ANCILLARY SERVICES PARAMETERS

Thank you for the opportunity to provide a submission on proposed parameters for calculating payments to Synergy for spinning reserve, load rejection reserve and system restart services.

Figure 1: Average balancing prices, actual and forecast (source: AEMO data, Synergy analysis; EY Margin Values Review for 2019/20).

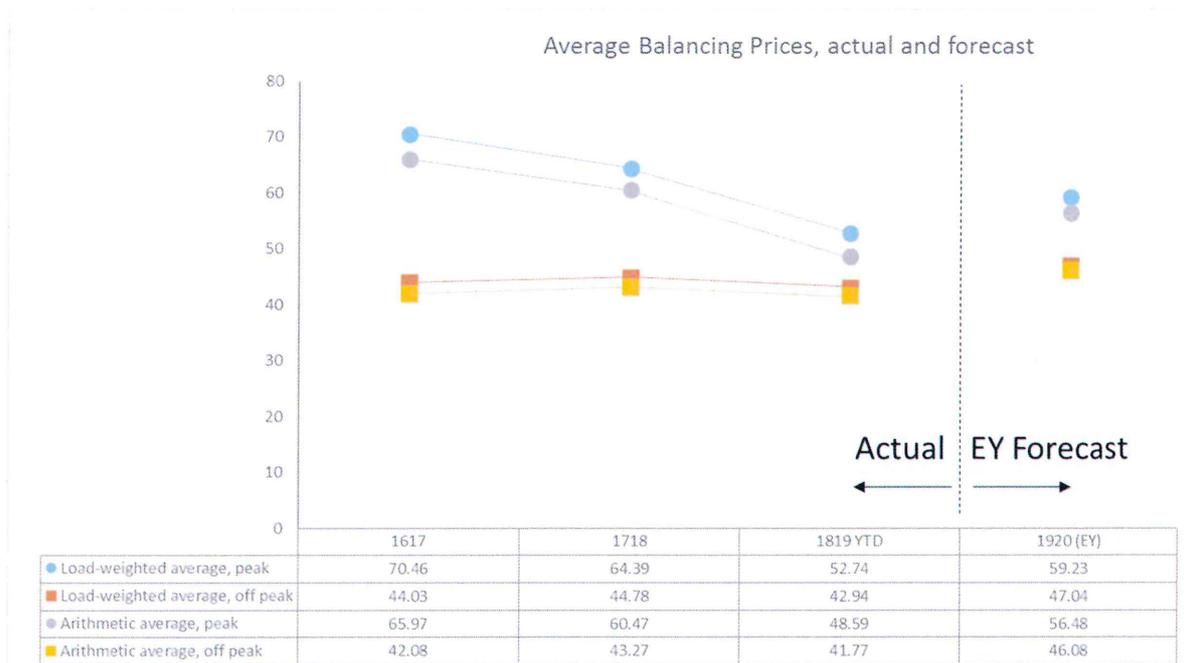
Synergy is concerned that the balancing price forecast in the model is implausible. The model forecasts that peak-period balancing prices in 2019/20 will increase by more than 10% over the levels observed year-to-date in 2018/19. This finding contradicts both recent trends (refer

Figure 1 below) and the likely effects of the increasing penetration of both small-scale and large-scale renewable generation. The price forecast has a direct, material impact on Synergy. If the assumptions in the model were adopted and balancing prices in 2019/20 were merely to stay the same as in 2018/19 without further decline, Synergy would under-recover its availability costs by around \$1.2m.
